Form 3160-5  
(August 2007)UNITED STATES  
DEPARTMENT OF THE INTERIOR  
BUREAU OF LAND MANAGEMENTFORM APPROVED  
OMB No. 1004-0137  
Expires: July 31, 2010Farmington Field Office  
Bureau of Land Management

## SUNDRY NOTICES AND REPORTS ON WELLS

HALE 3

## PLUG AND ABANDONMENT PROCEDURE

## Proposed P&A

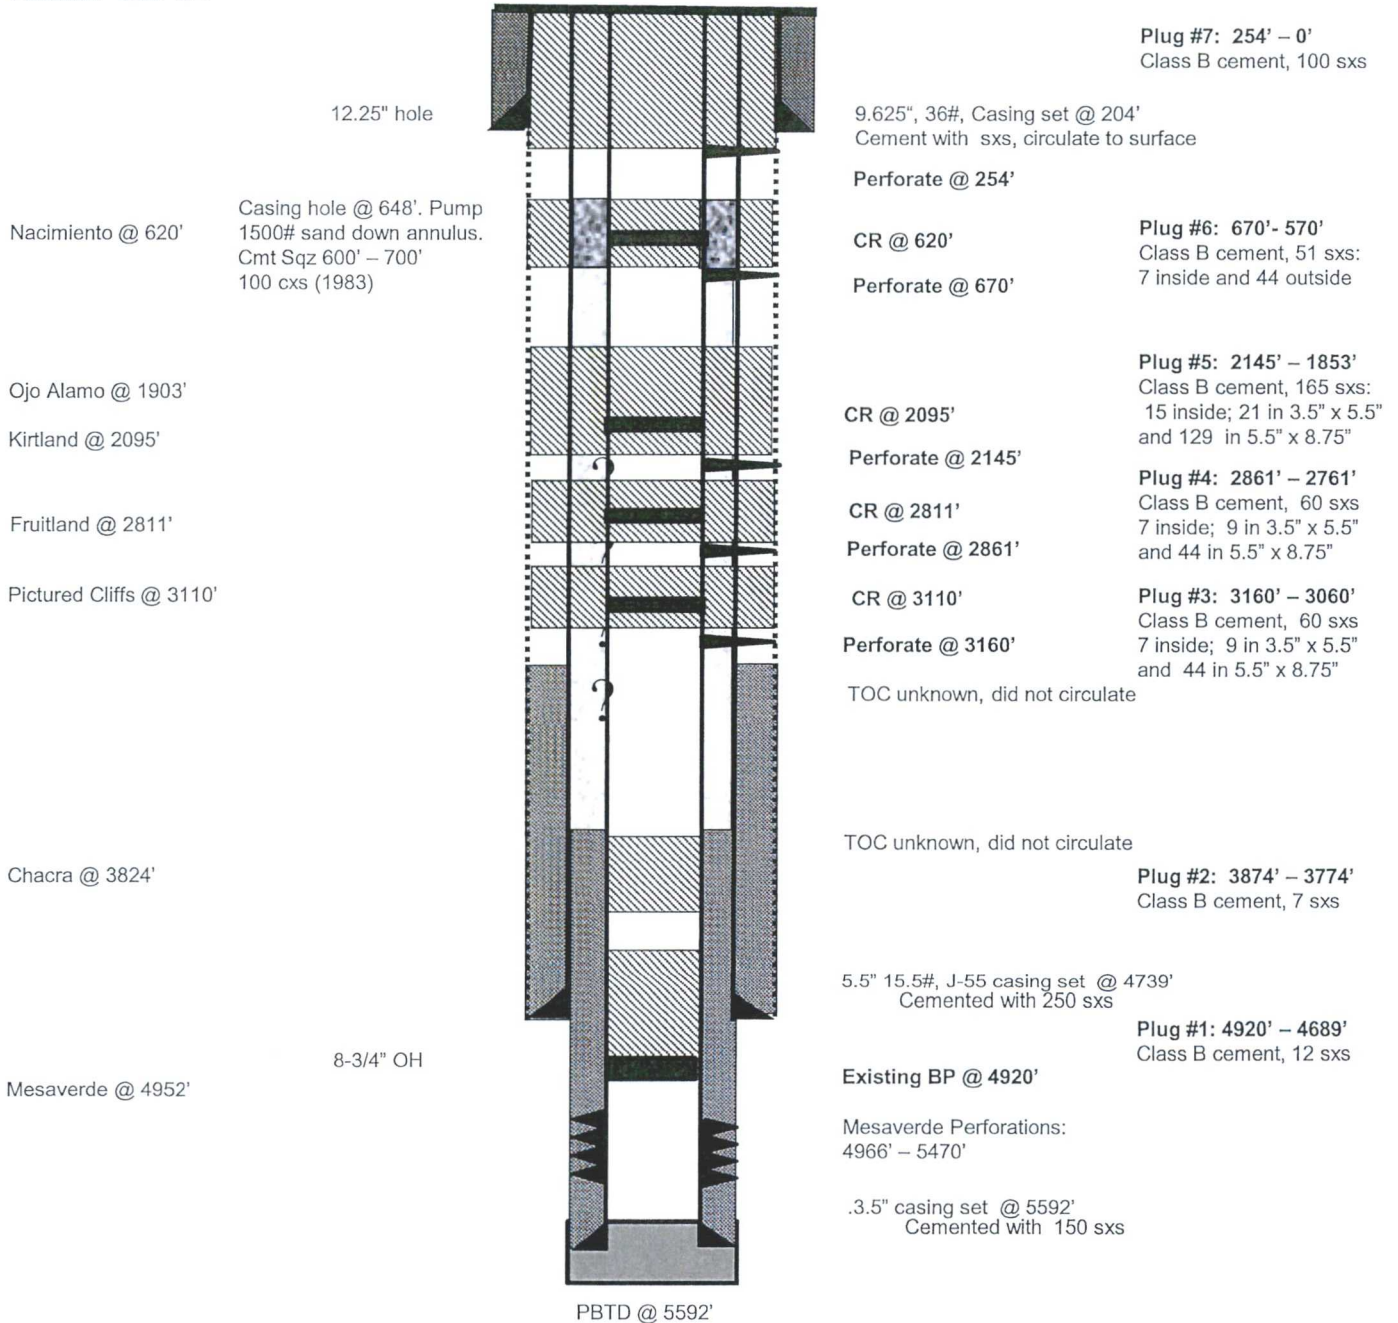
1. Plugging operations authorized are subject to the attached "General Requirements for Permanent Abandonment of Wells on Federal and Indian Lease."
2. Farmington Office is to be notified at least 24 hours before the plugging operations commence (505) 564-7750.
3. The following modifications to your plugging program are to be made:
  - a) Set Plug #2 (3130 – 3030) ft. to cover the Pictured Cliffs top. BLM picks top of Pictured Cliffs at 3080 ft.
  - b) Set Plug #4 (2800 – 2700) ft. to cover the Fruitland top. BLM picks top of Fruitland at 2750 ft.
  - c) Set Plug #6 (637 – 537) ft. to cover the Nacimiento top. BLM picks top of Nacimiento at 587 ft.

Operator must run a CBL to verify cement top. Submit electronic copy of the log for verification to the following addresses: [jwsavage@blm.gov](mailto:jwsavage@blm.gov) [Brandon.Powell@state.nm.us](mailto:Brandon.Powell@state.nm.us)
